Enclosure 2
Non-Proprietary Meeting Handouts

Approach for Response to TN-40 Transport Application RAI
July 29, 2008

Transnuclear, Inc.

Figure 1: Typical Control Rod Insertion

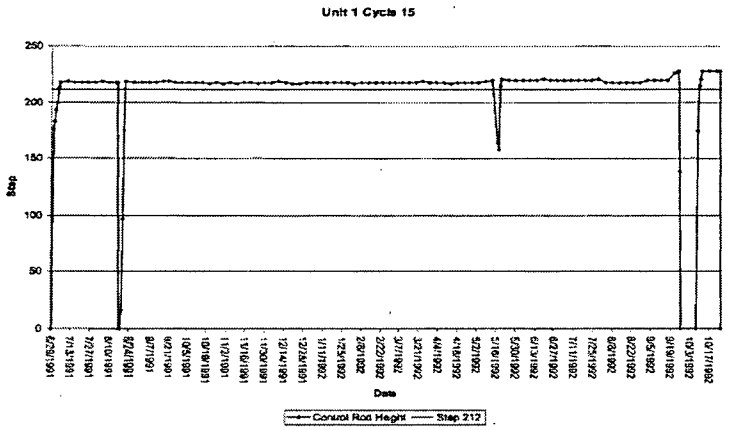
- **Control Rod Insertion**
  - *A detailed history of the Control Rod insertion for Prairie Island will be included in the RAI response submittal. Based on the information provided, it is clear that no significant control rod insertion activity occurred. A typical insertion profile is shown in Figure 1*
  - *Figure 2 shows an insertion profile for Cycle 1 where control rod insertion occurred. Based on the duration of insertion, the depletion of these fuel assemblies with control rods inserted is covered by those with BPRAs inserted for the entire cycle*

Figure 3: Typical Soluble Boron Letdown

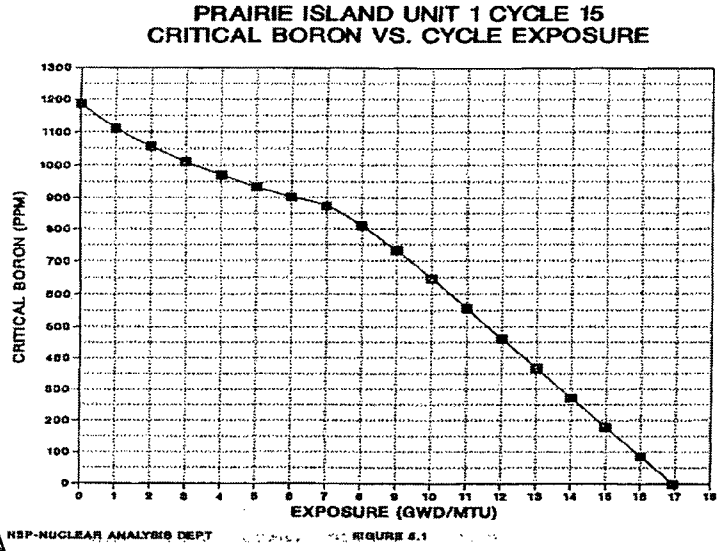
- ***Soluble Boron Letdown***
  - *A detailed history of the Soluble Boron Letdown for Prairie Island will be included in the RAI response submittal. A typical letdown curve is shown in Figure 3*
  - *A UNIFORM soluble boron concentration of 600 ppm was utilized in the depletion calculations and demonstrated to be bounding for Prairie Island specific evaluations*
  - *More discussions on Boron letdown modeling is included in subsequent slides*

Figure 4: Burnup Loading Curve

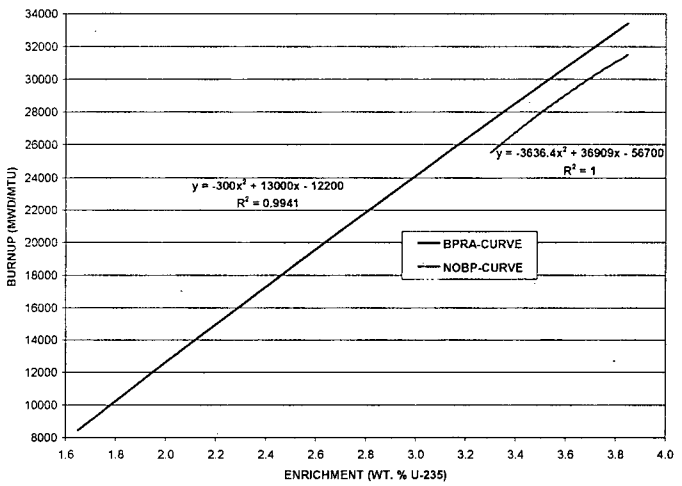
- *RAI 6-30*
  - *6-30: burnup loading curve*

- *A new, more refined, loading curve (shown in Figure 4) was developed based on new calculations – higher moderator temperature / lower moderator density*
- *Separate curves were developed for fuel assemblies depleted with and without BPRAs. No BPRAs were utilized in Prarie Island fuel assemblies for enrichment greater than 3.40 wt. % U-235*
- *BPRAs are not credited in the criticality analysis – neither for their absorption nor for their "water displacement" features*
- *Despite these conservative assumptions, the maximum calculated k-eff including all biases and uncertainties is 0.9335 which is approximately 4σ below the USL of 0.9370, demonstrating significant margins are still available.*
